WELL API NO. 30-015-34881
5. Indicate Type of Lease STATE ☐ FEE ☒
6. State Oil & Gas Lease No.
7. Lease Name or Unit Agreement Name OXY BENELLI
8. Well Number #001
9. OGRID Number 157984
10. Pool name or Wildcat [96819] SALT DRAW; MORROW, WEST (G)

SUNDRY NOTICES AND REPORTS ON WELLS (DO NOT USE THIS FORM FOR PROPOSALS TO DRILL OR TO DEEPEN OR PLUG BACK TO A DIFFERENT RESERVOIR. USE "APPLICATION FOR PERMIT" (FORM C-101) FOR SUCH PROPOSALS.)	
1. Type of Well: Oil Well ☐ Gas Well ☒ Other	
2. Name of Operator OCCIDENTAL PERMIAN LTD	
3. Address of Operator P.O. BOX 4294 HOUSTON, TX 77210	
4. Well Location Unit Letter D : 990 feet from the NORTH line and 660 feet from the WEST line Section 8 Township 25S Range 28E NMPM County EDDY	
11. Elevation (Show whether DR, RKB, RT, GR, etc.)

PROPOSED WBD

Operator: OCCIDENTAL PERMIAN LTD P.O. Box 4294 Houston, TX 772104294	OGRID: 157984
	Action Number: 378358
	Action Type: [C-103] NOI Plug & Abandon (C-103F)

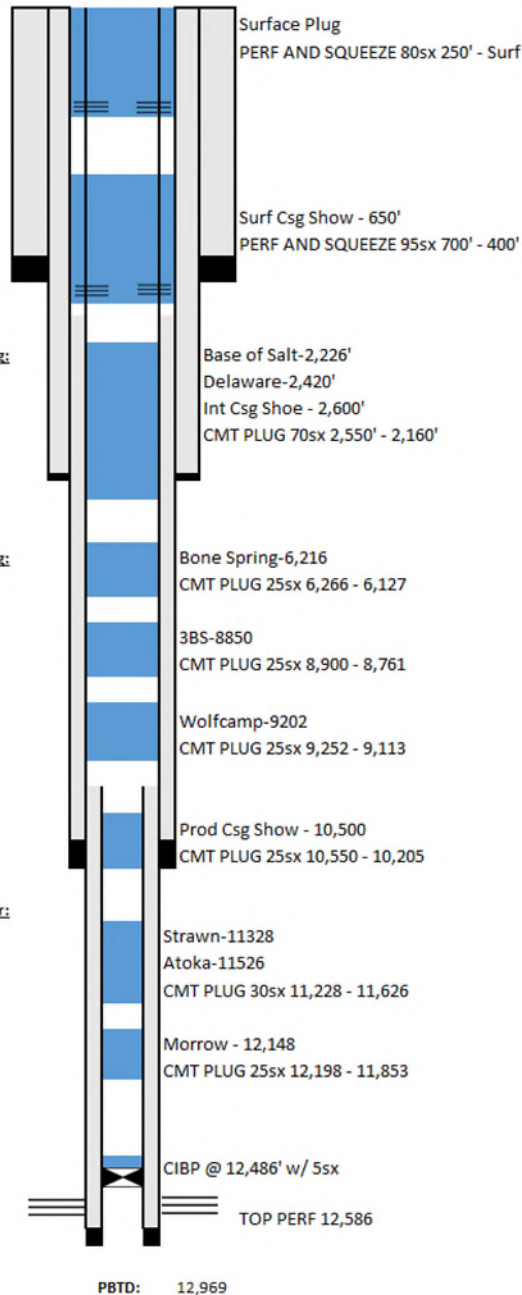
See CBL - Perforate as needed
WOC time is 6 hours

- PLUGGING PROCEDURE** CIBP @ 12535' Test casing 500psi/30min -Bubble test - Run CBL to surface
1. SET CIBP @ 12,486. - PRESSURE TEST AT 500psi. DUMP 5 SX CLASS H CMT. WOC. TAG and Test Casing at 500psi for 30min.
2. SPOT 25 SX CLASS H CMT 12,198 - 11,853'. WOC. TAG
3. SPOT 60 SX CLASS H CMT 11,228 - 11,626. WOC. TAG
4. SPOT 30 SX CLASS H CMT 10,550 - 10,205. WOC. TAG
5. SPOT 30 SX CLASS H CMT 9,252 - 9,113. WOC. TAG
6. SPOT 30 SX CLASS H CMT 8,900 - 8,761. WOC. TAG
7. SPOT 30 SX CLASS H CMT 6,266 - 6,127. WOC. TAG
8. SPOT 70 SX CLASS H CMT 2,550' - 2,160'. WOC. TAG
9. PERF AND SQZ 45 SX CLASS C 700' - 400'. WOC TAG
10. PERF AND SQZ 35 SX CLASS C 250' - Surf. WOC. TAG
- Spot 25 sx cmt @ 3500' - Spacer plug
